To: Jimmy Fentress, Stroud Engineering
From: Brian Chambers, Senior Planner; 910.342.2782
CC: File;
Date: 6/30/2020
Re: Marshes at Rives Edge River Road Improvements TRC Review 2

Engineering has reviewed the plans for The Marshes 3, 4 and 5 project submitted June 11, 2020 and have the following comments:

RIVER ROAD RIGHT OF WAY IMPROVEMENTS

THE MARSHES
 PHASE 3

OWNER: RIVERS EDGE I, LLC	DESIGNED: JHF
ADDRESS: 1224 PEMBROKE JONES DRIVE WILMINGTON, NC 28045	DRAWN: JHF
PHONE: (910) 819-8814	APPROVED: JHF
STROUD ENGINEERING, P.A. 102 SUITE D CINEMA DRIVE WILMINGTON, NC 28403 (910) 815-0775	DATE: 6/05/19
	SCALE: 1" = 40'
	SHEET 5 OF 9

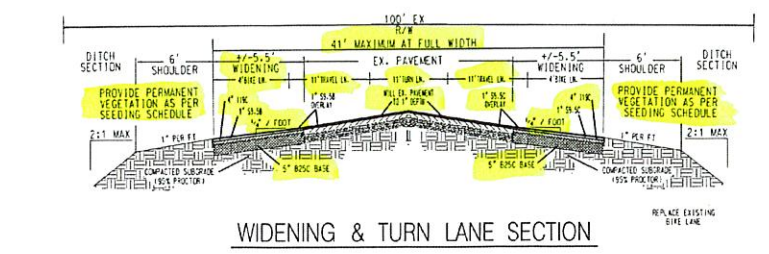
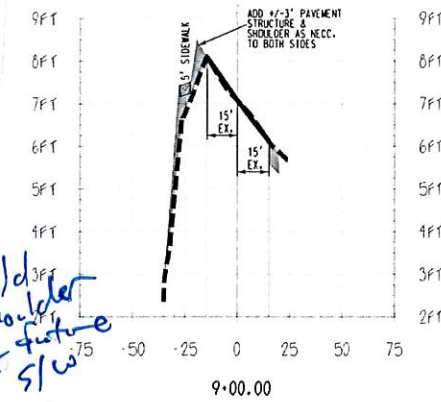
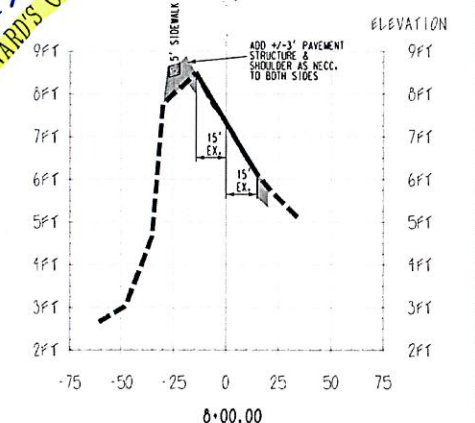
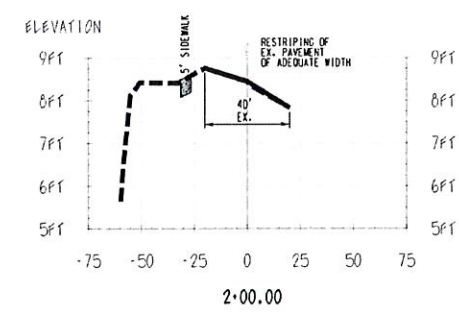
Comments on Sheet 5 of 9

2. With your recommended coordination with CFPUA adjacent project, have you seen any plans? This will affect the "DIP" repair scope in the pavement
3. Plans say, "Level Dip in Ex. Pavement" up near the bridge. Adding more pavement to settling pavement is not a satisfactory solution. Would recommend having Geotech look at this area and recommend a more permanent fix. Possibly remove, stabilize subgrade, and replace pavement as needed here.

4. If no work is happening around Guardrail you may retain it. But I do not feel like that is the case here. Since we are performing work in and around the existing guardrail, the project needs to update the guardrail to current standards which would involve removing and resetting the guardrail to the 2'-1" required height and to have the TL-3 anchor units installed on the ends.

5. Label radius proposed on sidewalk meander around poles/guy wires....would recommend this be smoother (at least 20' reverse curve).
6. Show a curb and gutter flare detail; recommend 20' radius taking face of curb at least 2' back further away from EOP; then tapering asphalt pavement at a 10:1 to this point. (If you need a sketch let me know).

7. Show/label any "wet utility" adjustments to be performed (i.e. valve adjustments, manhole adjustments, FH relocates, etc.) on the plans for the Contractor to perform with appropriate CFPUA details).

8. Show/label any "dry utility" conflicts/adjustments and label who you need to coordinate those conflicts with. These need to be coordinated ahead of construction (i.e. guy wires, poles, utility handholes, gas valves, pedestals, etc.).
Please note that Duke Energy has recently installed some new poles and guy wires along roadway; Engineer will need to review any additional conflicts with these.

9. Existing there are three (3) front/back Chevron signs (MUTCD W1-8); See MUTCD section 2C.10 for Chevron Alignment and proper installation height/size.

10. Please note on plans that in the area where you are not building sidewalk (Sta 7+00 to 9+00 +/- LT) shoulder (12' wide with 3:1 slopes) still needs to be constructed and seeded.

Show label w/ utility conflicts
Show flare detail

EX. GUARDRAIL TO REMAIN *May be able to retain if no work is happening here*

OWNER: RIVERS EDGE I, LLC	DESIGNED: JHF
ADDRESS: 1224 PEMBROKE JONES DRIVE WILMINGTON, NC 28045	DRAWN: JHF
PHONE: (910) 819-8814	APPROVED: JHF
 STROUD ENGINEERING, P.A. 102 SUITE D CINEMA DRIVE WILMINGTON, NC 28403 (910) 815-0775	DATE: 6/10/20
	SCALE: 1" = 20'
	SHEET 5A OF 9

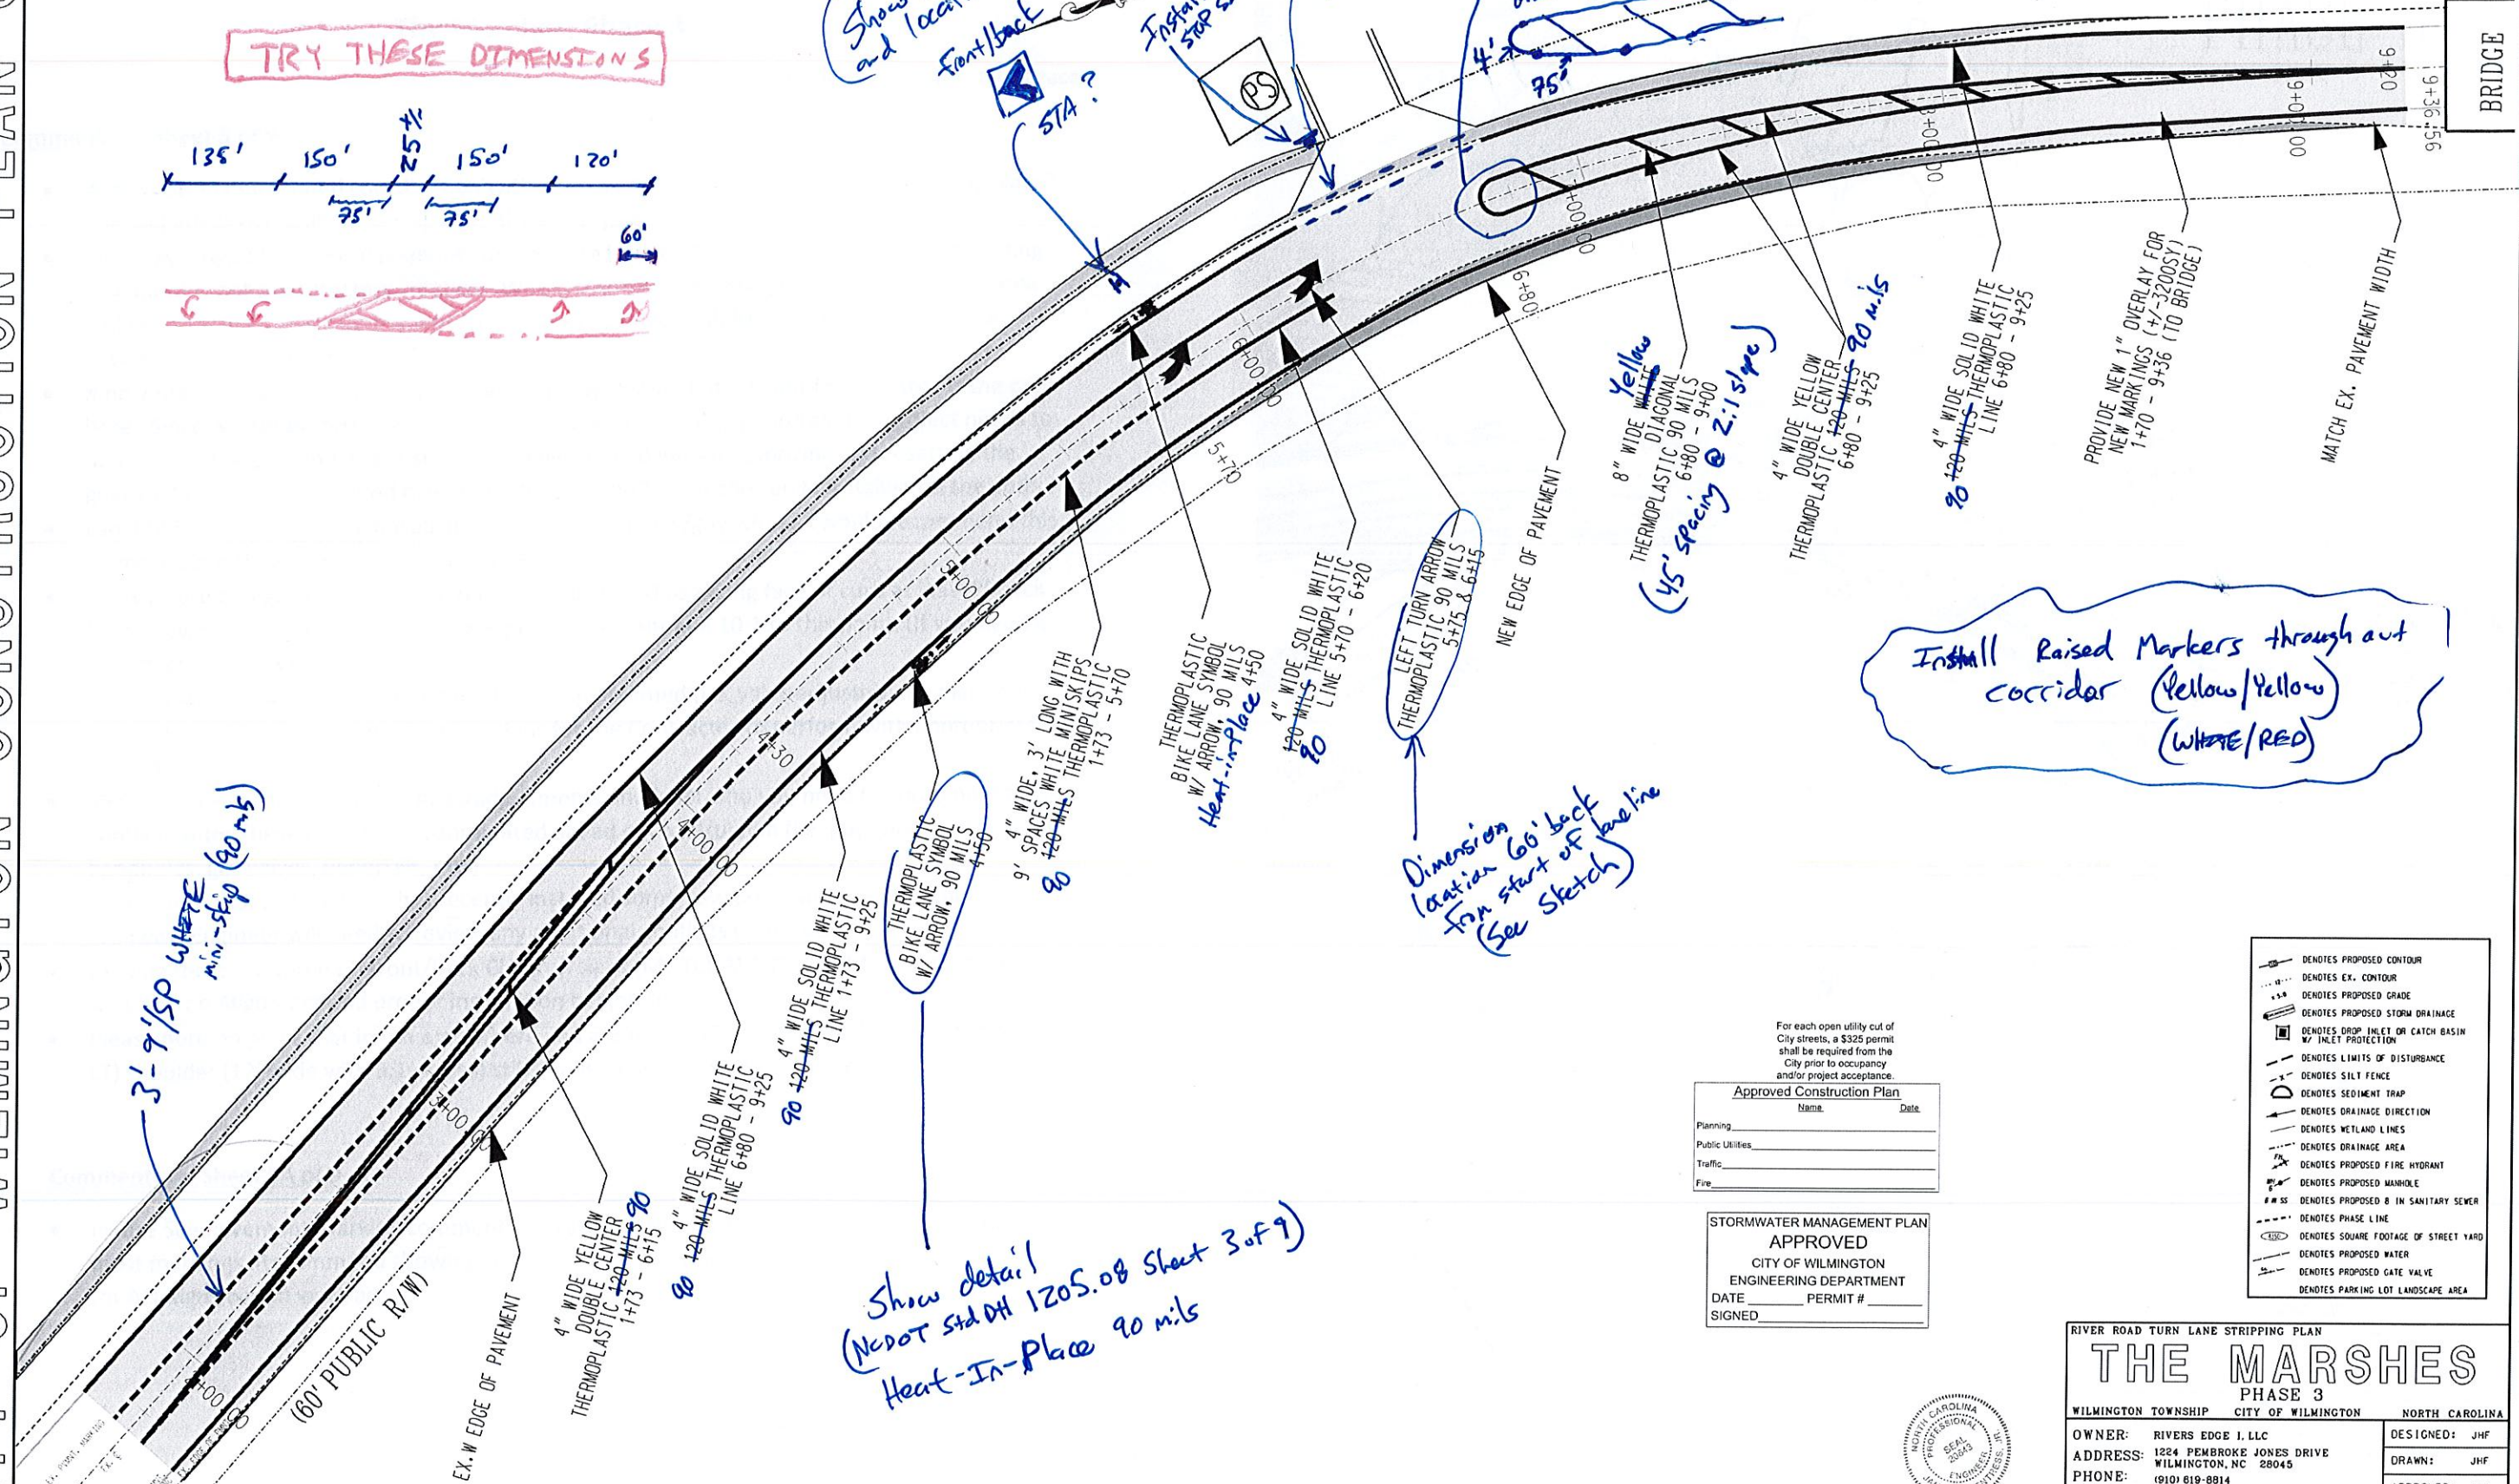
Comments on Sheet 5A of 9

11. Please See Pavement Marking comments and sketch; NCDOT has been going with 90 mils now on most markings; Recommend showing signs on pavement marking plans; Show retain or

relocate for ALL signs within work area. Coordinate with Randall Glazier, Signs & Markings Engineer (#341-0069, Randall.Glazier@wilmingtonnc.gov).

TRY THESE DIMENSIONS

(Show signs and location)
 Front/back
 STA ?
 Install STOP SIGN

Recommend 7 one small radius and one large radius

3'-9 1/2" SP WHITE Mini-strip (90 mls)

Install Raised Markers throughout corridor (Yellow/Yellow) (White/Red)

Show detail (NOT STD 1205.08 Sheet 3 of 9) Heat-In-Place 90 mls

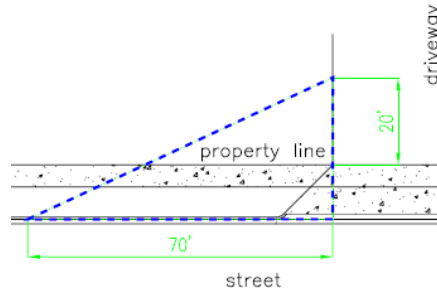
- The City's 20'x70' sight distance triangle at the driveway is not shown correctly. Refer below image and revise. [Sec.18-529(c) (3) CofW LDC] [Sec. 18-812 CofW LDC]. Add a note indicating that all proposed vegetation within sight triangles shall not interfere with clear visual sight lines from 30"-10'. [Sec.18-556 CofW LDC]

- **SIGHT DISTANCE TRIANGLE FOR ANY STREET/DRIVEWAY INTERSECTIONS WITH THOROUGHFARES**
River Rd is a major thoroughfare [Chap VII (C) (2) (a) of CofW Tech Stds]. In accordance with the City Code, sight distances along thoroughfares must be calculated in compliance with the AASHTO requirements. [Chap VII (C) (1) of CofW Tech Stds] [Sec.18-556 CofW LDC]. Show AASHTO in addition to 20'x70' SDT.
